ASOS MODIFICATION NOTE 51 (for Electronics Technicians)

SUBJECT : Class I Automated Surface Observing System (ASOS) Solid-State Time Delay Relay (SSTDR) for the Acquisition Control Unit (ACU)

PURPOSE : The addition of an SSTDR ensures a proper reset of the Class I ACU ASOS system (*system without an Uninterruptible Power Supply (UPS)*) during a loss of power.

AUTHORIZATION : This modification is authorized by ECP **E985M05F187C**.

Figure 1 SSTDR on the Din Rail

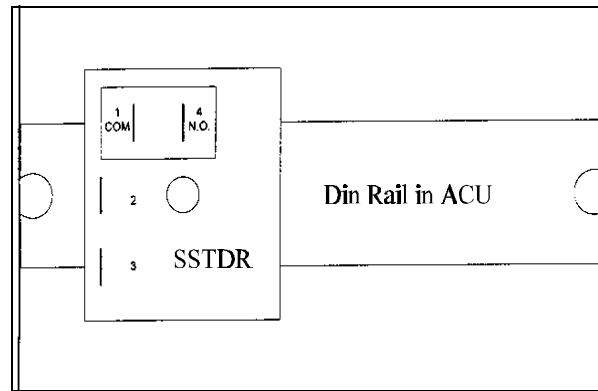
1. Remove AC facility power from the ACU.
2. Open the rear door to the ACU.
3. Locate the Din Rail that supports the power distribution block (PDB), 1A7.
4. Install the SSTDR bracket on the Din Rail to the right of the PDB.
5. Install the SSTDR on the bracket using the #1 phillips machine screw.
6. Locate and disconnect wires 1A7-18C and 1A7-23A. Cap and tie the wires back.
7. Connect the following wires between the SSTDR and PDB, 1A7: (Use figures 1 and 2 on the following pages for reference) It may be easier to connect the wire if the Din Rail is removed from the shelf. Remove the screws at either end of the Din Rail.

Figure 2 General Wiring Diagram

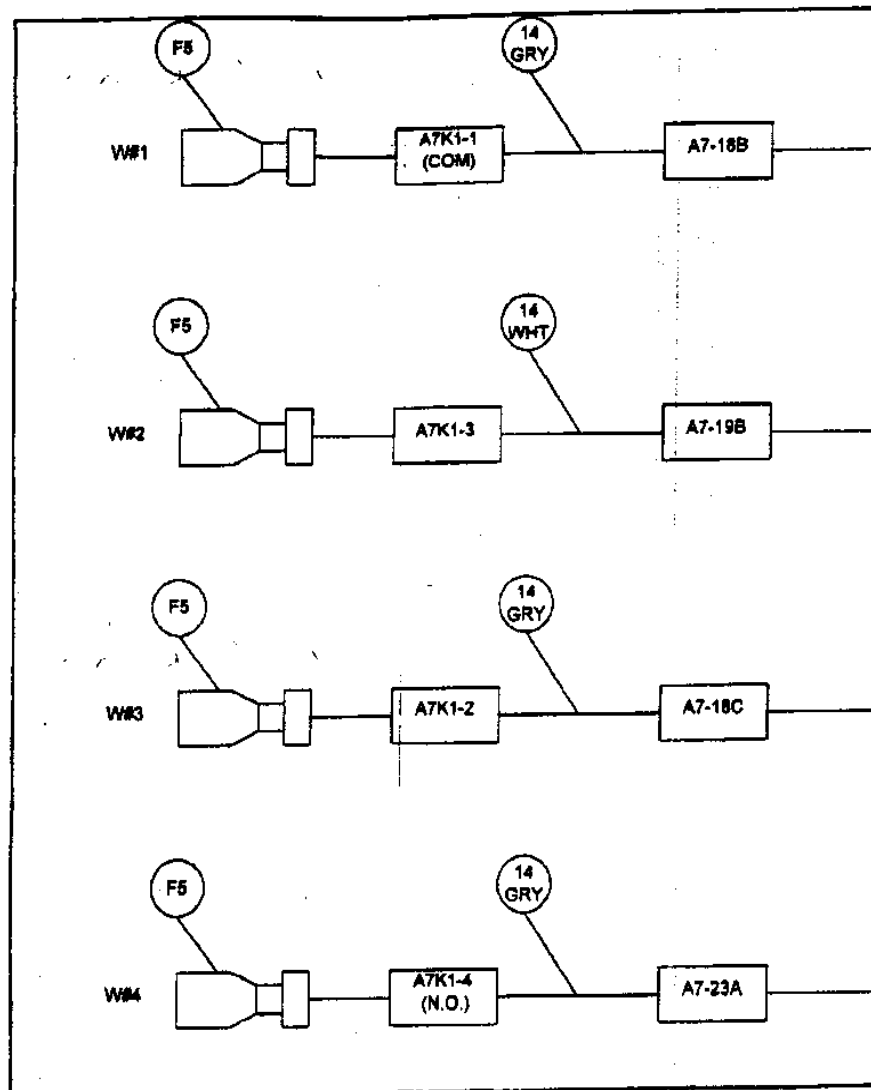
From W138 Wire Harness		To Location on the PDB	ACU Wire Number
Gauge + Color	Wire Number		
14GRY	1A7K1-1 (COM)	1A7-18B	ACU W #1
14WHT	1A7K1-2	1A7-18C	ACU W #2
14GRY	1A7K1-3	1A7-19B	ACU W #3
14GRY	1A7K1-4 (N.O.)	1A7-23A	ACU W #4

8. Reinstall the Din Rail when wiring is completed.
